County of Fairfax, Virginia

Re: Interpretation for PCA 80-L-004, Loisdale Business Center, Tax Map 90-4 ((1)) 3: Site Layout, Parking, Stormwater Management and Architecture

Re: Determination Request for PCA 80-L-004
Loisdale Business Center
(Tax Map 90-4-((01)) Parcel 3)

Re: Supplemental Information for Determination Request for PCA 80-L-004
(originally submitted 10/6/11)
Loisdale Business Center
Tax Map 90-4-((1)) Parcel 3

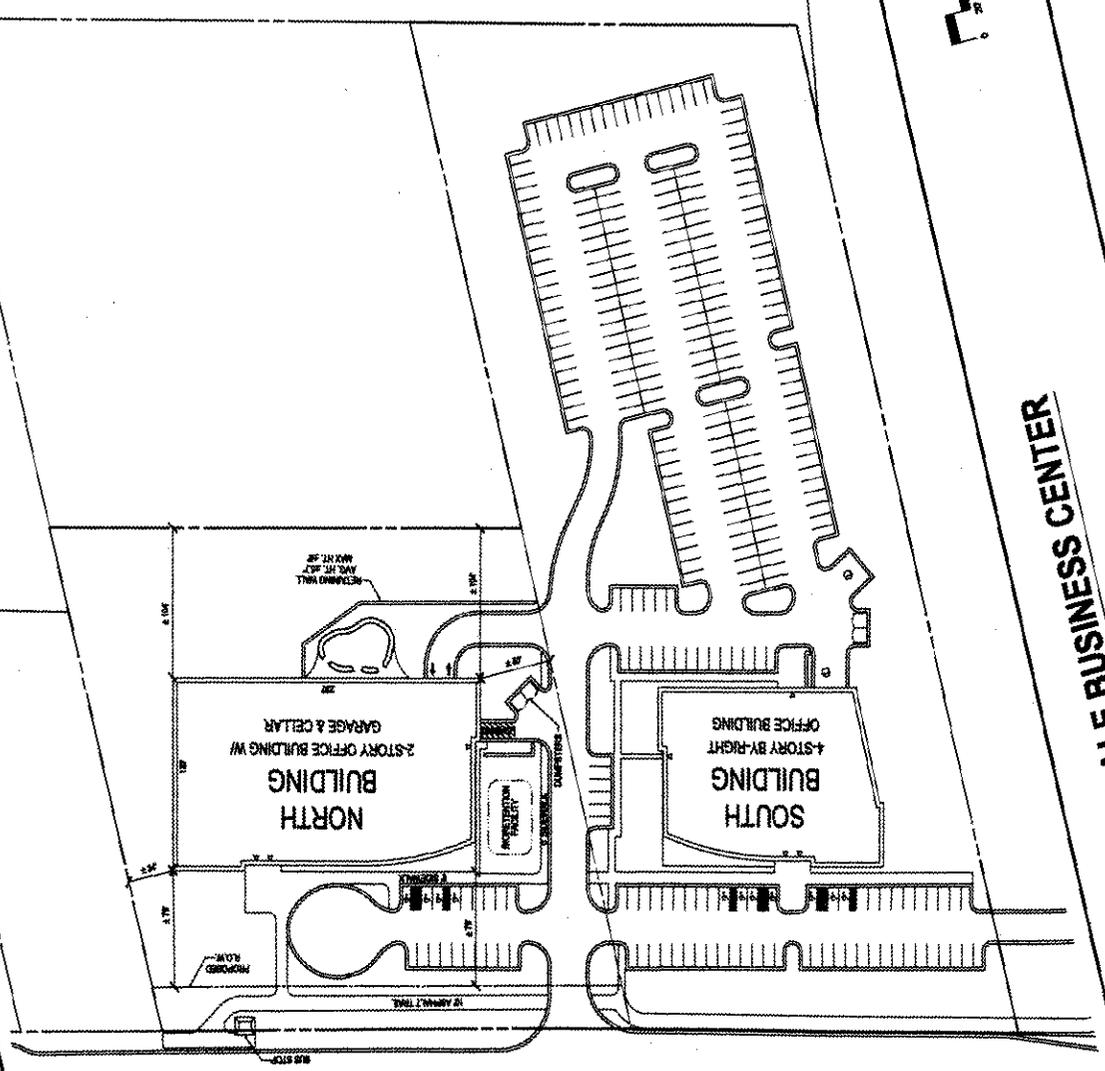
As requested, I'm providing an updated Cadd exhibit that reflects the layout identified on the Alt "A" sketch provided to you on February 10, 2012. As we have previously discussed, the surface parking lot will have 19 surface spaces and the parking garage will have 160 spaces for a total of 179 which meets the requirements of a 59,476 GFA building as approved on the rezoning plan. Please note that there was an error on the rezoning plan that computed required parking spaces for the 5,750 sf of the parking garage described as "cellar". The computations were incorrectly computing the parking requirement based on a portion of the parking garage. We are not proposing a cellar and are providing parking based on the proposed GFA of 59,476.

The proposed open space is 41% with the attached plan which exceeds the 40% identified on the zoning plan.

The phosphorous removal efficiency will be approximately 58% which will be achieved with the use of a bioretention facility and conservation easements. It is noted that the Site Plan associated with the rezoning plan was reviewed and recommended for approval with a removal rate of 58.4%.

It is my determination that the proposed modifications to the site layout (entrance, garage, loading, dumpster), parking, stormwater management and architecture would be in substantial conformance with the proffers and the GDP, provided that all other proffer commitments continue to be met, and subject to approval by the Department of Public Works and Environmental Services (DPWES). Given that PCA 80-L-004 only governs Lot 3, it does not ensure that the proposed consolidation will occur, or that the by-right portion of the consolidation will be developed as proposed. As such, it is essential to maintain compliance with the PCA proffers and GDP in the context of both the consolidation and independent of the consolidation. Therefore, in the event that the proposed two building office project is submitted as a consolidated site plan, separate tabulations shall be included in the site plan for the property subject to PCA 80-L-004 to demonstrate compliance with the proffers and the GDP.

Elevation Sketch - Study 1, Version 1

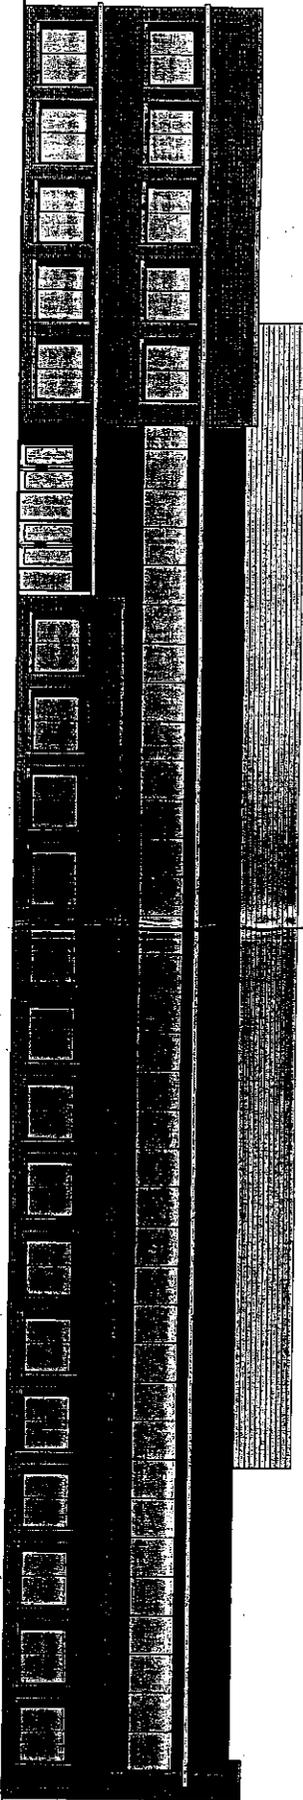
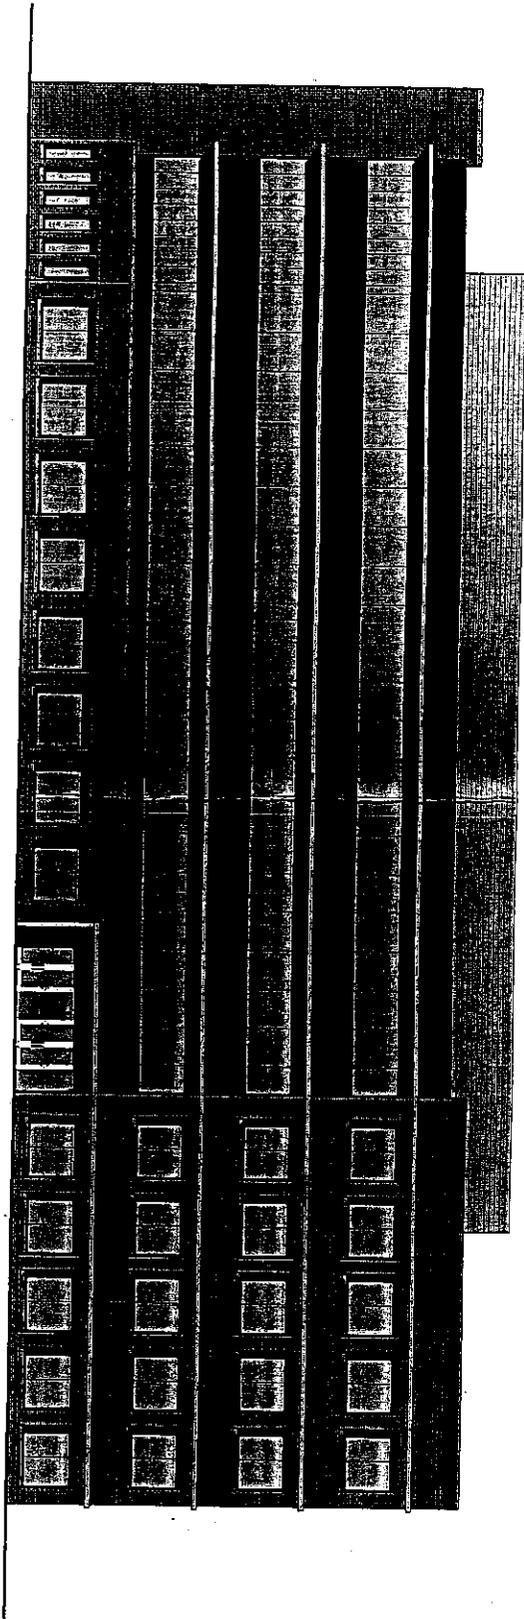
- Architecture. The architectural elevations depict the building without the raised domelike structure above the atrium. Glass and masonry materials would still be used for the façade of the building.

- The North Building architecture and building materials will be in general conformance with the elevations shown on Sheet 10 of the GDP. The architecture for the South Building will complement the North Building. Proposed architectural elevations have been provided for your reference. Please note that the loading and garage entrances have been relocated to the side and rear of the building respectively, to improve the front building elevation appearance and to improve vehicular circulation.

Elevation Sketch - Study 1, Version 1

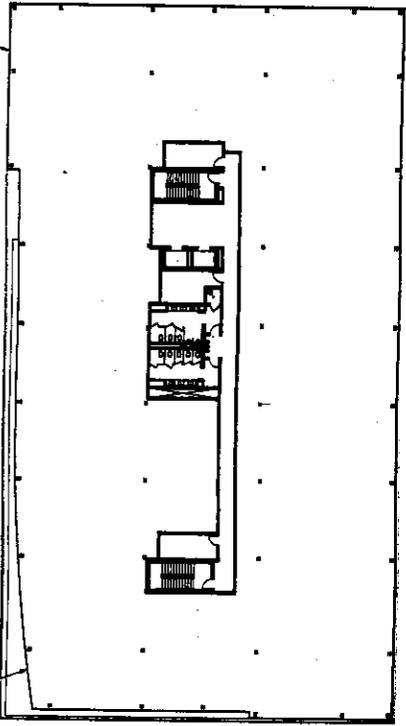
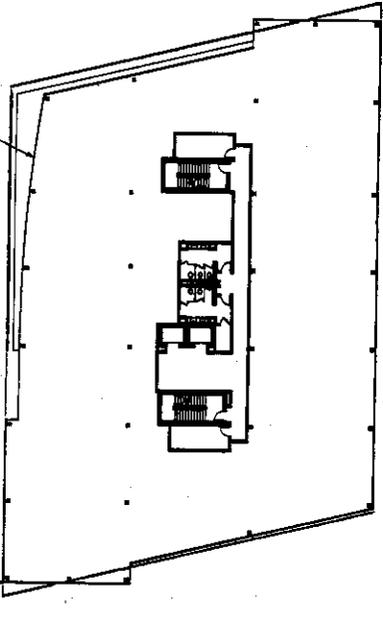
Use sunshades as accents and to define the building entry

Masonry Corner Bookends
 > Heavy masonry corners at both North and South building creates bookends that clearly tie the two buildings together visually and define boundaries of the site

TRAFFIC
 Buildings most visible in this direction

Subtle curve
 > opens up views to North Building, allows better visibility of North Building signage from Southbound 95
 > acknowledges the main drive between the buildings
 > creates another unifying design element

Most Visible Portion of Site from 95
 > emphasizes the vertical with proportions of masonry / openings
 > use deep set windows to create a sense of heaviness
 > mass, material, and deep shadows will create a foundation and a unifying feature
